RE: Strata Energy Ross In Situ Recovery Project LQD Permit to Mine No. 802 Non Significant Revision to the Permit

RE: Strata Energy Ross In Situ Recovery Project LQD Permit to Mine No. 802 Non-Significant Revision to the Permit, Update to Mine Plan Section 4.1.1

Subject: Round 1 Review, Mine Plan NSR

PM Ring to Aquifer Exemption Buffer Analysis

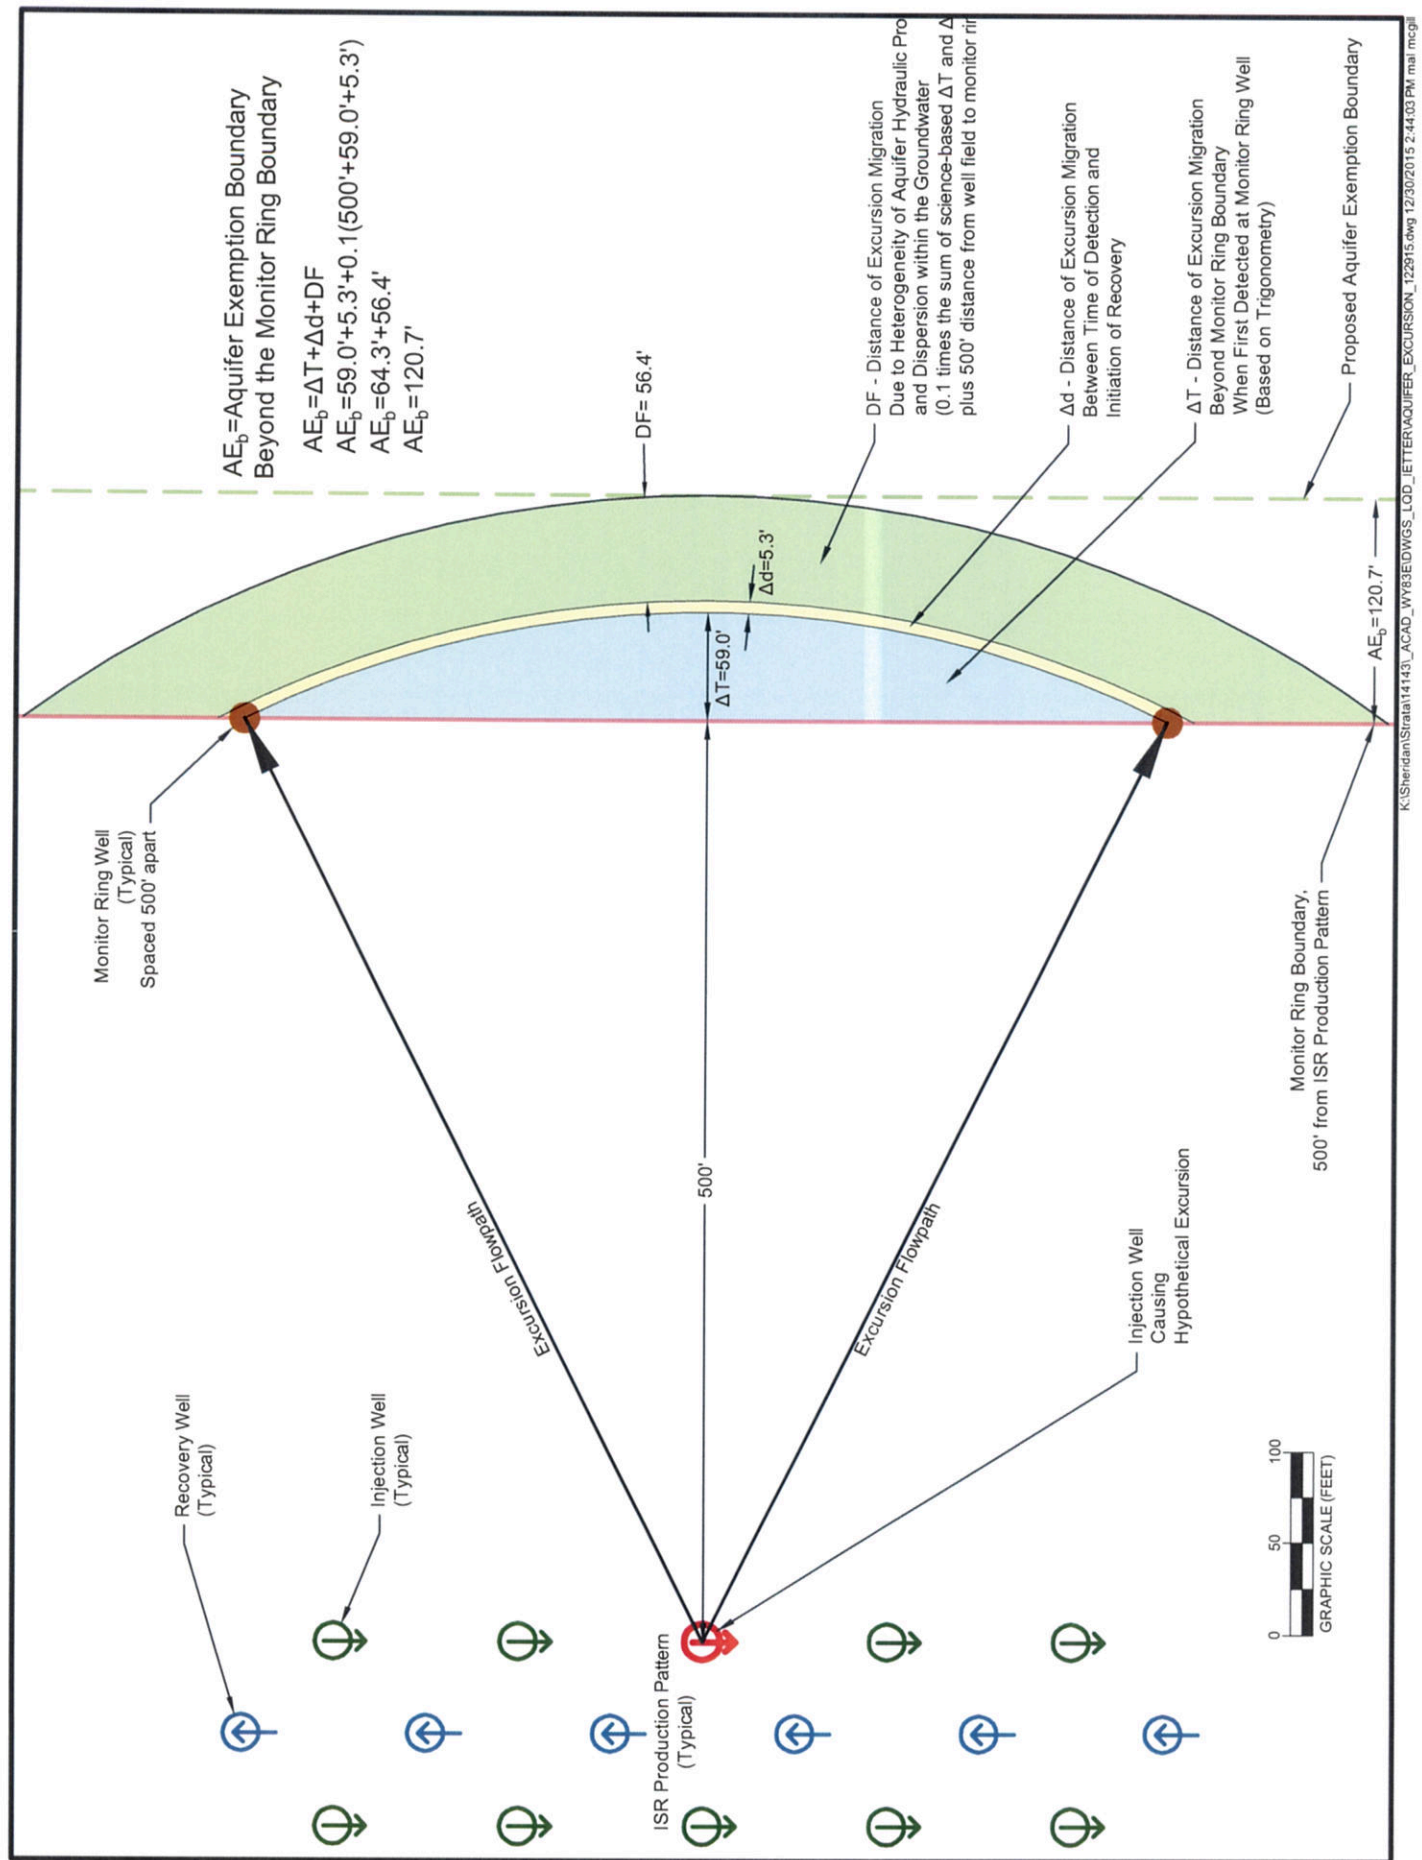
areas. Therefore, Strata's proposed variable well spacing and offset is appropriate, and offers much needed operational flexibility with the same or perhaps enhanced ability to timely detect lateral solution migration. Clearly, with the requested flexibility in PM well spacing and offset distances, the commitment in Section 4.1.2 of the Mine Plan to confine uranium recovery operations in the exempted aquifer remains unchanged and in full effect. At LQD's request, Attachment 2 provides the buffer analysis for a spacing and offset distance of 500 feet, the maximum that Strata would install PM wells. In this scenario, the buffer distance between the PM wells and aquifer exemption boundary is calculated to be 120 feet. Similarly, the buffer distance at the minimum spacing and offset distance of 300 feet was calculated to be 75 feet.
